STAFF REPORT
(ADDENDUM)

CASE NUMBER: P.D. 08-324 CC **L.U.C.B. MEETING:** December 11, 2008
Held from November 13, 2008

DEVELOPMENT: WOODLAND HILLS II PLANNED DEVELOPMENT, AMENDED

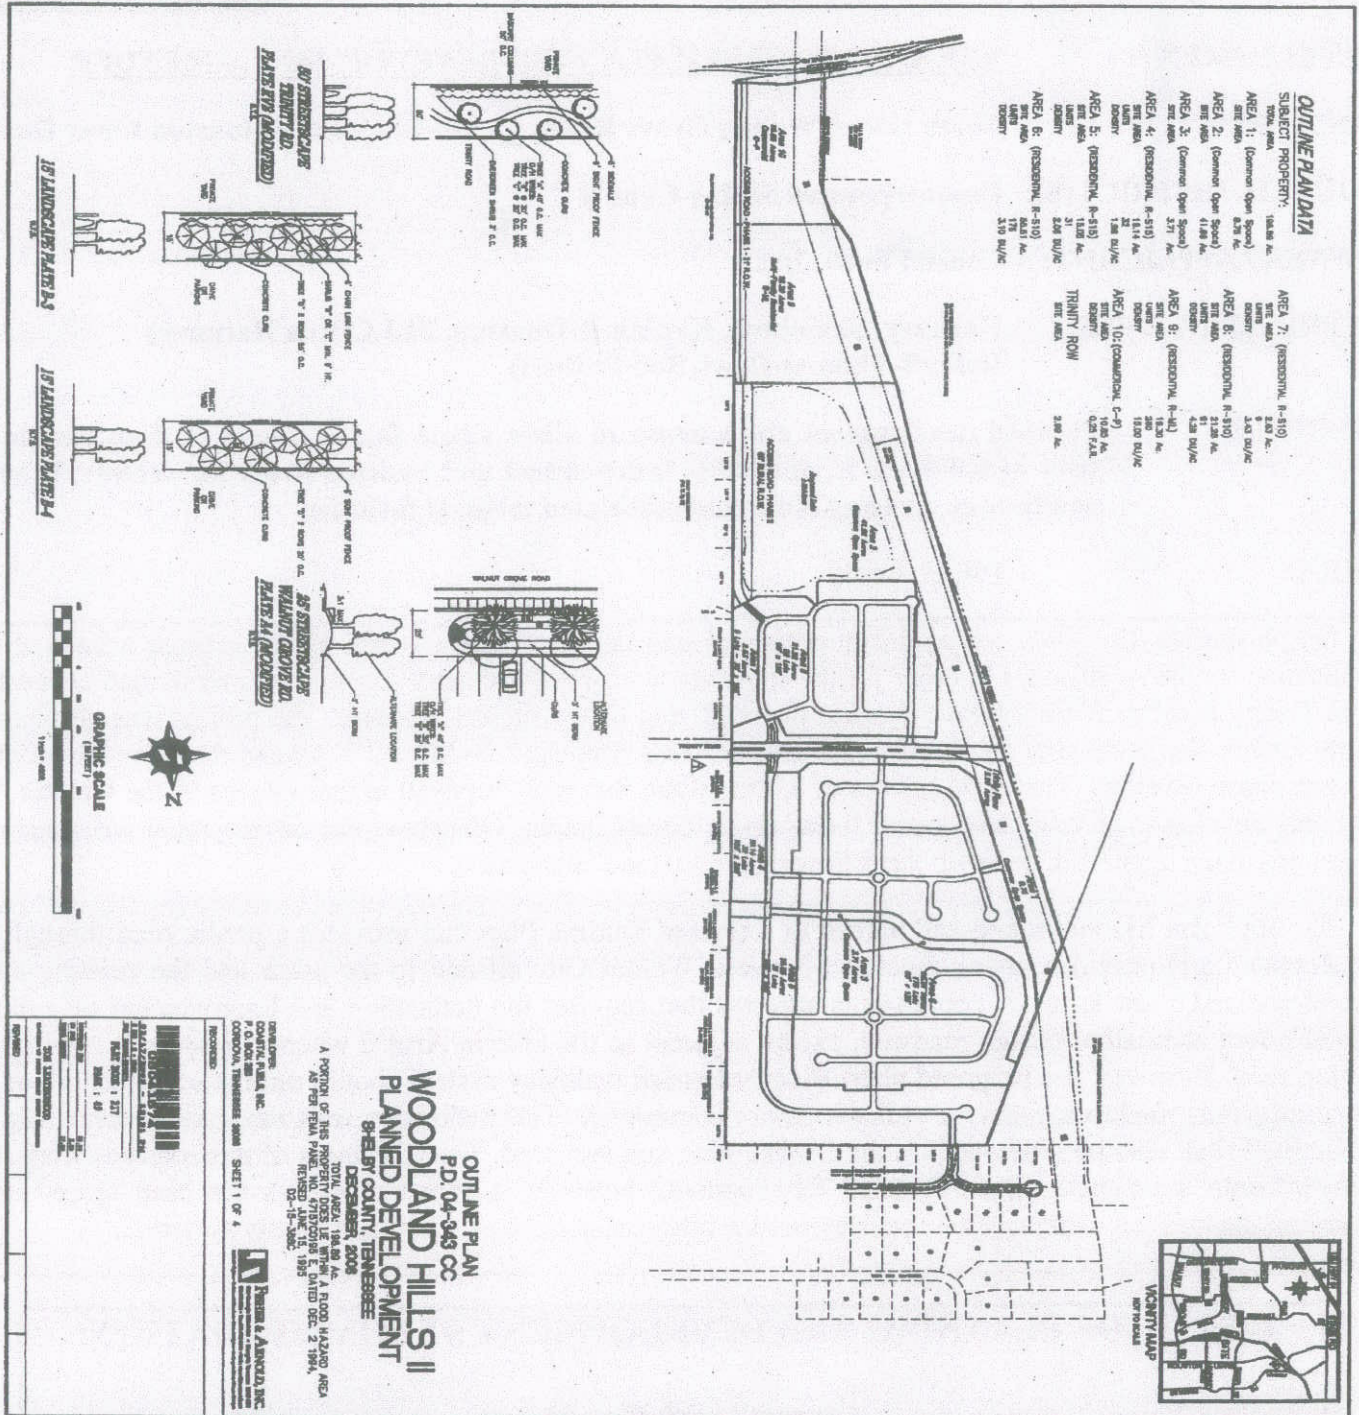
On November 13, 2008, the applicant requested and the Land Use Control Board granted a hold of this application for thirty(30) days in order for the applicant to consult with staff regarding a public road connection from Trinity Road to Walnut Grove Road at the south end of the subject property. The project was also held to allow further clarification of alternative land uses in Areas 6A-Alt, 7, 8-Alt and 9-Alt and the inter-connectivity as each phase develops. The development of 6,000 square foot lots proposed in these Areas of the Outline Plan will only develop as private gated senior living single family homes. Otherwise, the development will remain as it was originally approved, but with the following public road connection.

The applicant has submitted and agreed to a revised Outline Plan that provides a public road through the development and provides inter-connection between Walnut Grove Road to the south and the existing street stub Woodland View Lane. A condition is attached that requires the dedication and improvement of a thirty-one(31') foot alternative design roadway, except adjacent to the lake in Area 2 where it may be a rural cross-section road. However, the proposed alternative pedestrian walkway system should run the entire length of the proposed public road to maintain a walkable senior community. This pedestrian walkway system, including the public road shall also be illustrated on the Outline Plan and recorded. The alignment of this roadway may shift eastward onto the Canale Grove Planned Development; however, a compromise has not been agreed upon regarding the location of this public roadway nor the inter-connection of a public roadway system.

OFFICE OF PLANNING AND DEVELOPMENT RECOMMENDATION:

Approval with Conditions

SOUTHERN ACCESS ROAD-PHASING PLAN:

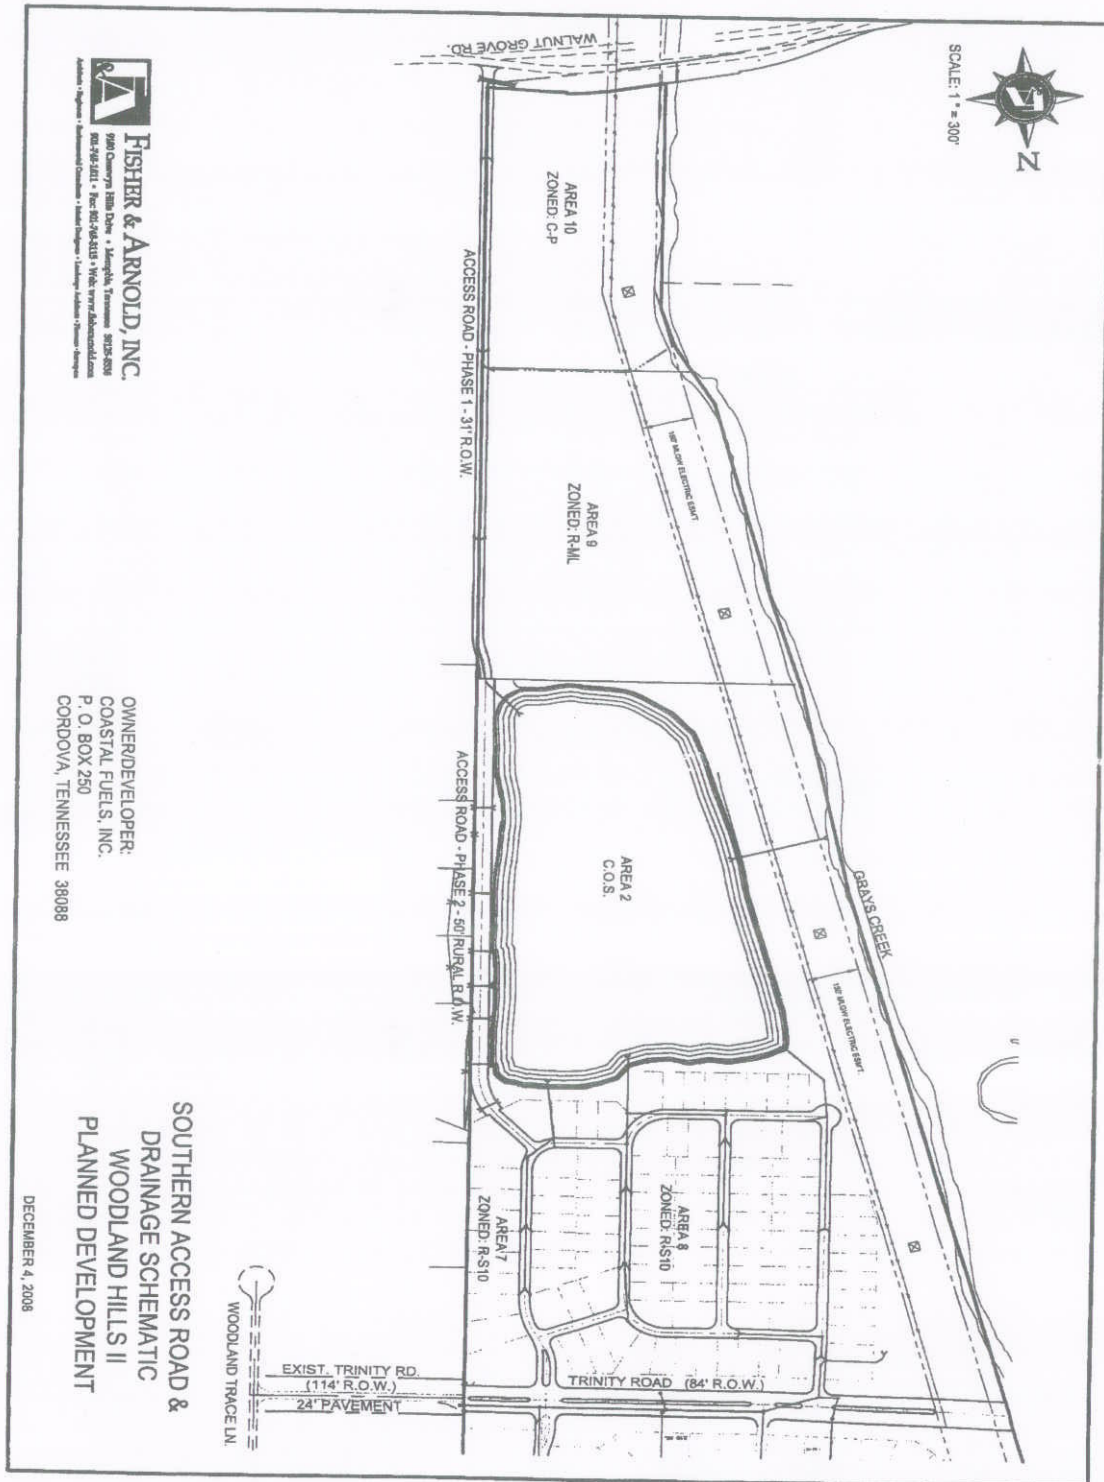
- E. Dedicate and improve a public road extending from Walnut Grove Road to connect with Woodland View Land on the north. The street cross-section shall be a thirty-one(31) foot wide alternative design through Areas 4,5,7, 9 and 10 and fifty(50) foot wide rural design road through Area 2.

- Q. The north/south road may be developed in phases contiguous with each phase of development.
- R. Four (4) curb cuts shall be allowed in Area 10.
- S. Three (3) curb cuts shall be allowed in Area 9.
